We would like to thank the referee for the review and comments to improve the quality of this work. Following these comments, we have made major modifications and point-by-point responses. Please find our response below (in blue).

This study represents a good first step in attempts to characterize the AERIS instrument performance for methane and ethane concentration measurements. The ultimate goal of this study is to assess the suitability for a suite of 4 AERIS instruments to be employed in a regional tower based flux study over the Denver-Julesburg Basin (DJB) as shown in Fig. 2. **This reviewer recommends publication of the methane results after major revisions, as discussed below. The ethane results, however, are more problematic and will require additional data and validations. Instead I would bill the AERIS ethane measurements as a work in progress requiring further validation.** This study rightfully places a large emphasis on the interference due to water vapor, and more specifically on how differences in water vapor between calibration and measurement cycles can result in biases. The 10-day laboratory comparisons of the retrieved AERIS methane concentrations from all 4 te

Figure Caption: Absorbance simulations for a 15 m pathlength, sampling cell pressure of 240 m bar and a temperature of 42°C. HITRAN 2020 absorption parameters of methane and water were employed in these simulations with Harrison ethane absorption parameters (not incorrect HITRAN values).

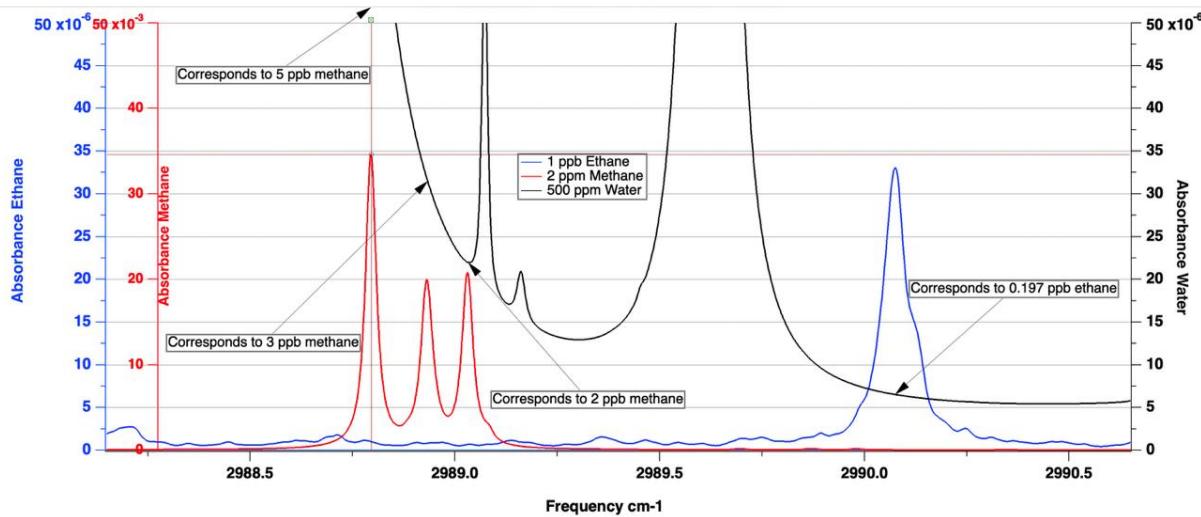
that water vapor concentrations need to be retrieved along with the methane and ethane values to assess in real time the Nafion scrubber performance in order to effect corrections. To the degree possible, this reviewer also recommends a close examination of the software fitting algorithms and parameters employed. Specifically, are the methane results based on one, two, or all three lines, and what are the absorption parameters employed (line positions, absorption and broadening coefficients, etc.)?

Thank you for the general comments and the detailed analysis. We really appreciate it. It's great to see that the water vapor effects we see are in the expected range based on your analysis. In fact, water vapor concentration was retrieved along with the methane and ethane values by the Aeris instrument. We added a phrase in Line 103 to clarify that point, "Typical differences between the dried sample and the humidified calibration gas, as measured by the Aeris instrument, were 100 - 500 ppm H₂O." We do have real-time water vapor concentrations used in this study to assess the Nafion scrubber performance and we assess the uncertainty related to the water vapor for each hour based on these values.

The software fitting algorithms are not open source, but we did get the following information from the manufacturer that "All three of the methane peaks are fitted and used to calculate the end concentration, they are weighed equally." We added the sentence, "In the wavelength range of the instrument, corresponding to frequencies of 2989.2 to 2986.4 μm, there are three methane peaks, and all are weighted equally to determine the mole fraction." to Line 73.

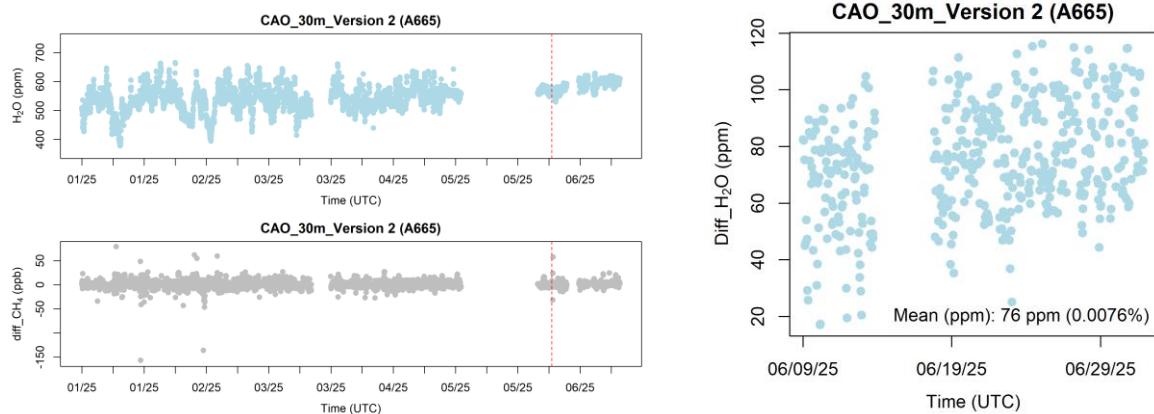
Line 258: Is it valid to ignore data with “large” atmospheric variability as detected by the Picarro? I am aware that this presents challenges in terms of precise timing and residence time issues, but large ambient swings could provide important additional tests of the AERIS instrument with potential large swings in water vapor. I would recommend trying to reanalyze these time periods if possible.

It was mentioned at Line 254-259 that “The NOAA Picarro line was flushed with an additional pump with a high flow rate such that the sample air takes only several seconds (8 - 14 s) to reach the instrument and the data were reported as 2-min means every 15 min. The Aeris instrument analyzed air from 30 m AGL using a dedicated sampling line. The flow rate for the Aeris was controlled at 110 sccm, using only the pump for the instrument. With this flow rate, the air took about 20 min to travel from the inlet to the Aeris MIRA Ultra. The timing difference was accounted for in the comparison. To minimize noise that might be caused by mismatches in timing, the hours with large atmospheric variability were removed.” Note the response to Reviewer 1, the sentences (Line 258-Line 260) were rewritten as “To minimize noise that might be caused by mismatches in timing, the hours with large atmospheric variability were removed (Levin et al., 2020; Richardson et al., 2017; Miles et al., 2018). We used a threshold of 7 ppb CH₄ for the standard deviation within each hour above which the data for that hour were excluded (Richardson et al., 2017).” Figure 9 was updated as shown below. The standard deviations are a bit larger, but the overall message is the same.

We used the Nafion in the system to dry the sample air. The Nafions react slowly to water vapor changes, providing a relatively stable value. For our current application (calibration every one hour), the difference of water vapor between the sample air and calibration cylinder remains small (below 100 ppm at CAO), and this water vapor difference caused uncertainty was calculated and documented in the data file. Below are the water vapor time series plot (from January - June 2025), the difference between the Aeris and NOAA Picarro CH₄ for that time period, and the difference of water vapor between the sample air and the calibration cylinder (June 2025). The water vapor was relatively stable and did not show large swings in water vapor corresponding to the large variation of methane.
